**Service Update
Second Half — 2010**

Prepared by: WHIRLPOOL CONSUMER CARE

PART NO. W10349156

Jenn-Air Dedicated Microwave Ovens

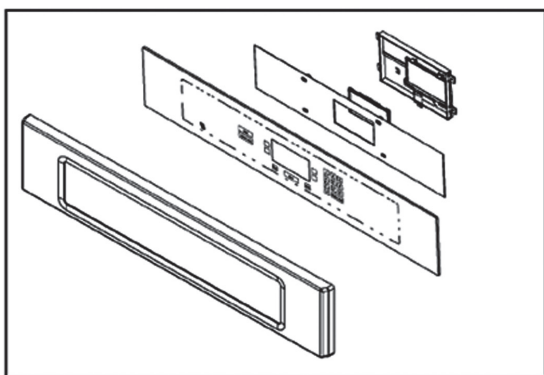
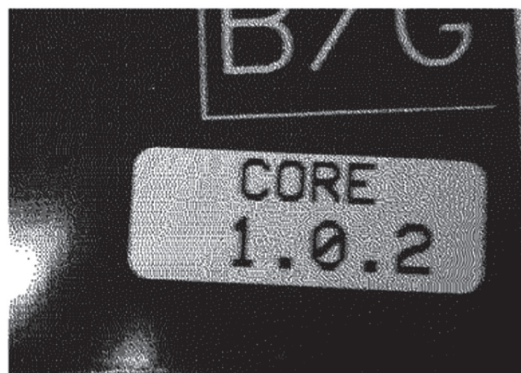
Number "3" may randomly appear in the display.

Control software issue.

Replace the control assembly. Service Pointer K8178811 (July 2010)

Service controls have been corrected and will have the software version tag as shown that indicates version 1.0.2.

Jenn-Air Slide-In Ranges

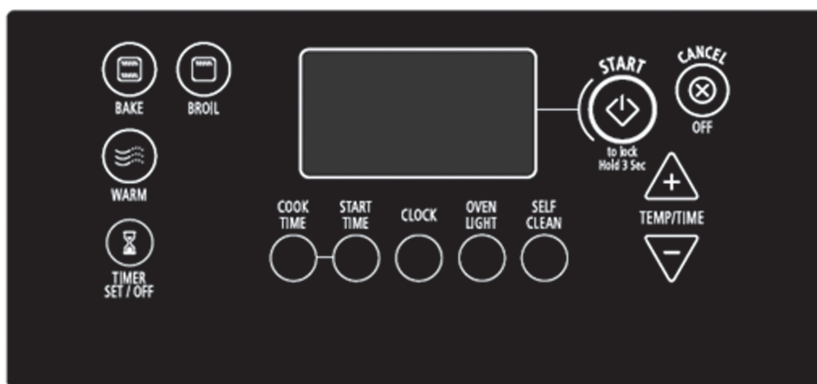
The keypads are too light, and difficult to see.

Color graphics are not bright enough.

The User Interface is being changed to more contrasting colors.

New Console assemblies are available as listed in the chart below. Current console assemblies, from parts lists, sub to the new part numbers listed.

K4317483
March 2010

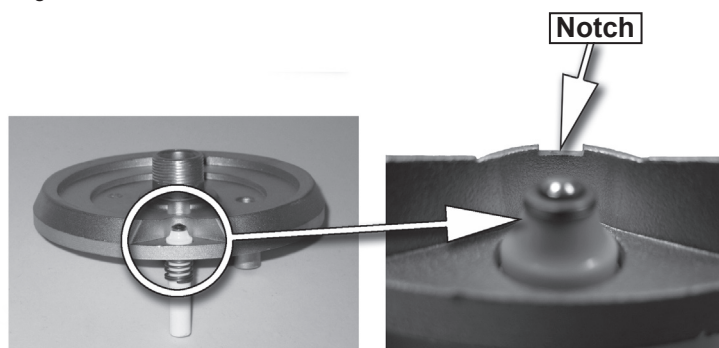
Large 20,000 BTU Stacked Burner(s) Not Lighting all the time.

Large Burner ignition port variation.

Replace Large Burner Base with new replacement part # W10320937. This new base has an added notch behind the ignitor. See Illustrations.

K8178811
June 2010

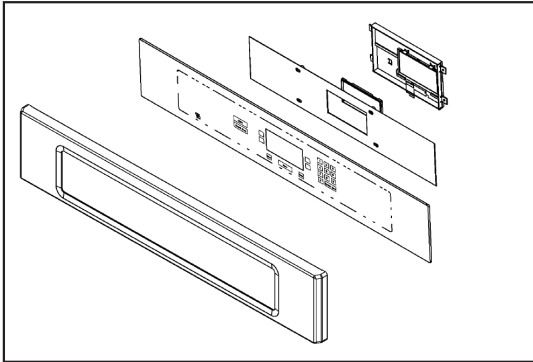
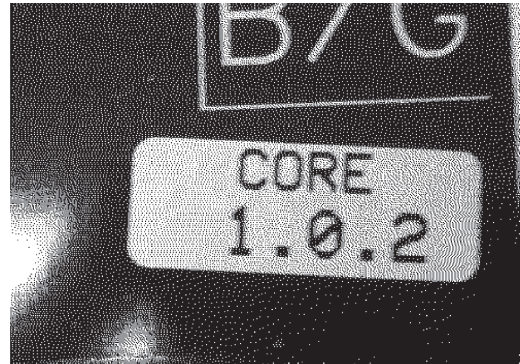
The number “3” may randomly appear in the display.

Control software issue.

Replace the control assembly.

Service controls have been corrected and will have the software version tag as shown below that indicates version 1.0.2.

Thread Lock On Leveling Nut

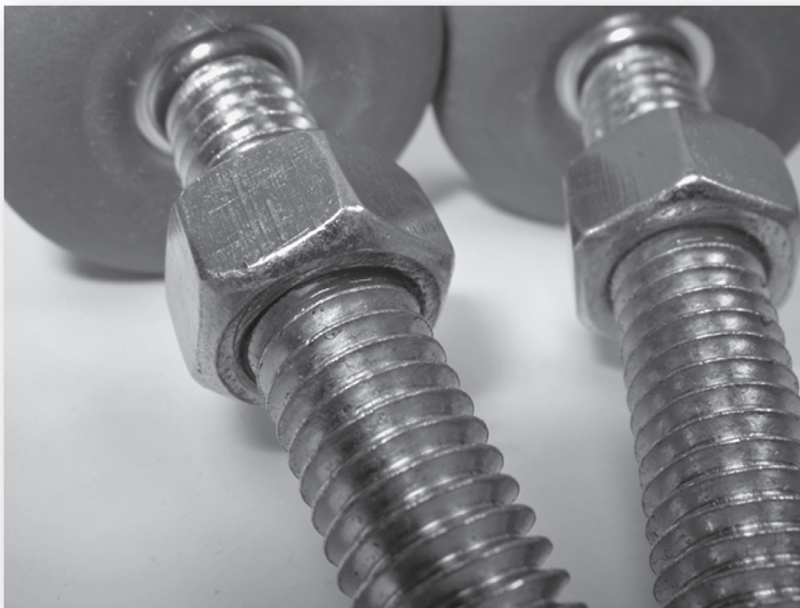
To aid in the manufacturing process the lock nuts will be secured to the threads of the foot with a thread locking compound. It will take a little bit of force to break the nut free if a foot height adjustment is needed. There is no need to use a locking compound on the treads for installation or service adjustments.

Replacement Start Switch Kit

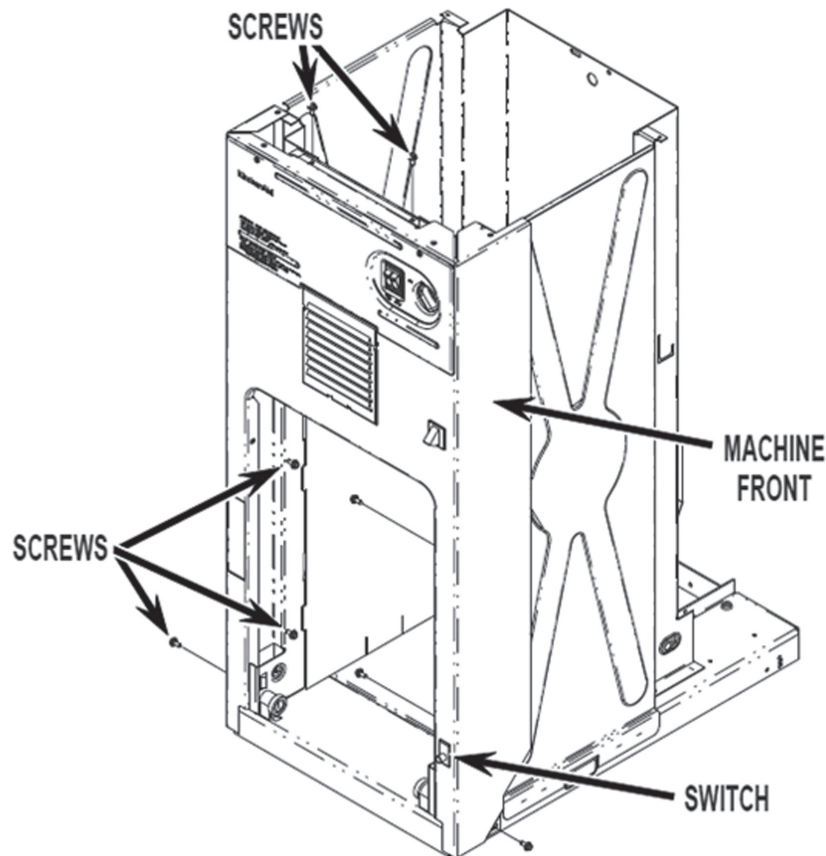
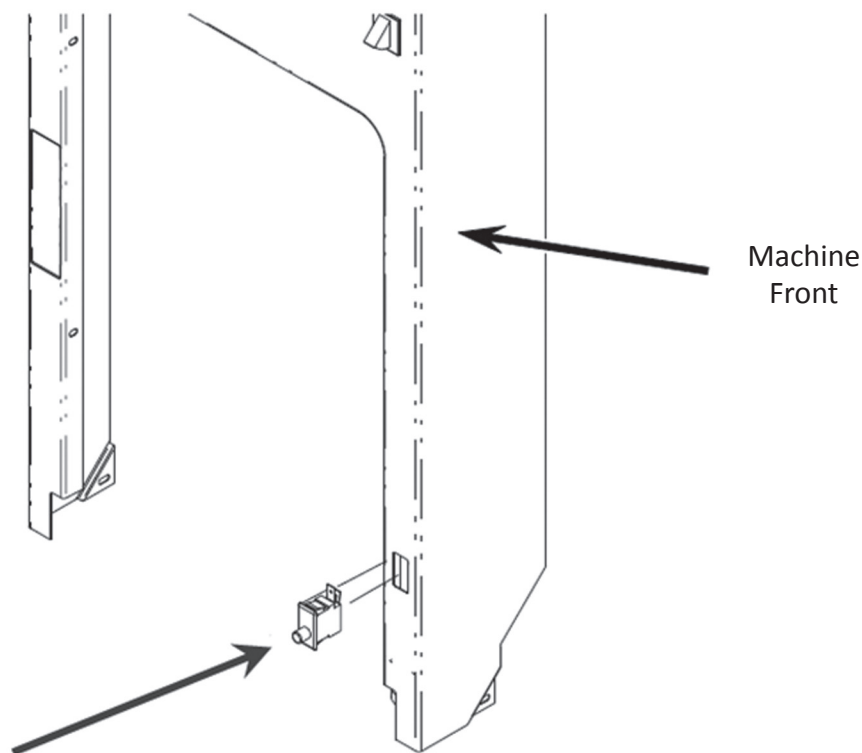
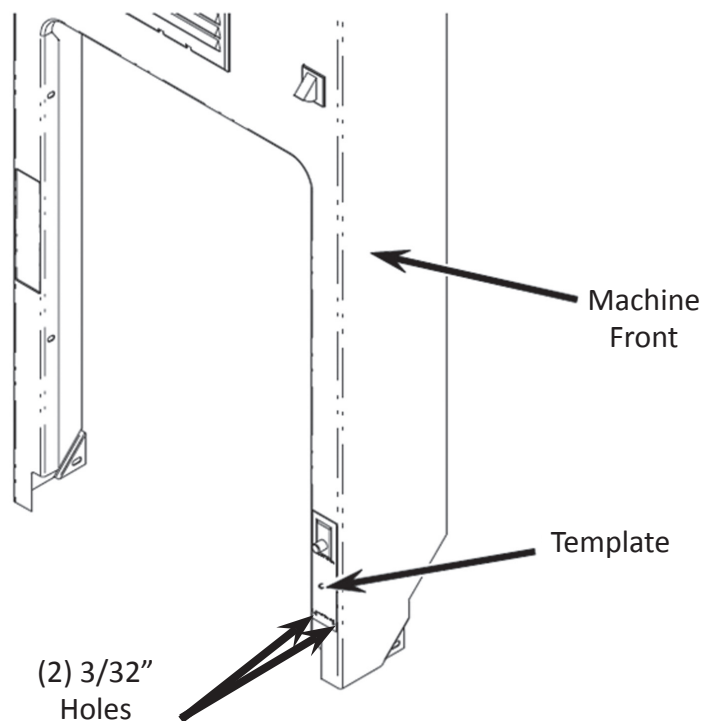
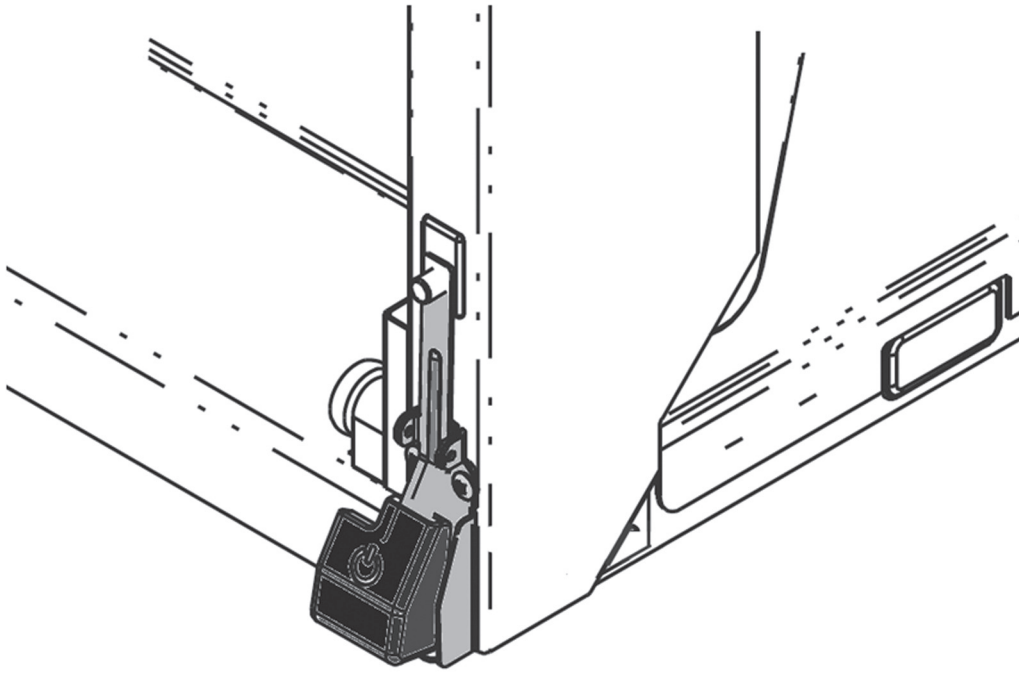
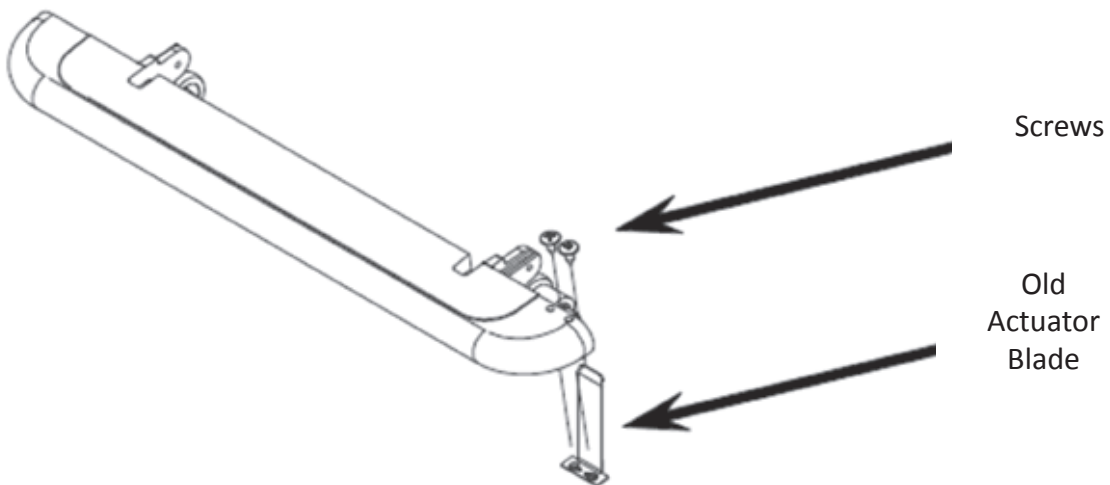
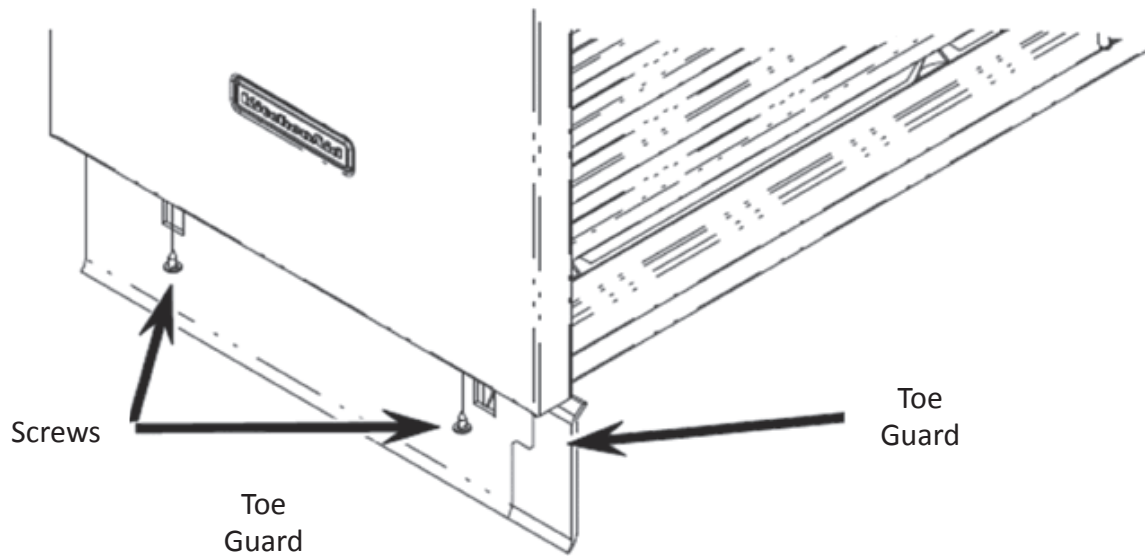
Starting in the second quarter, compactors went to a new integrated switching redesign. The switch has changed from a normally open switch to a normally closed switch that is held open by a new actuator lever. Replacement parts for the old switch will sub to a kit that contains: a normally closed switch, an actuator assembly, toe guard, a template, two screws and an instruction sheet.

Replacement parts sub to new kit - #W10342596
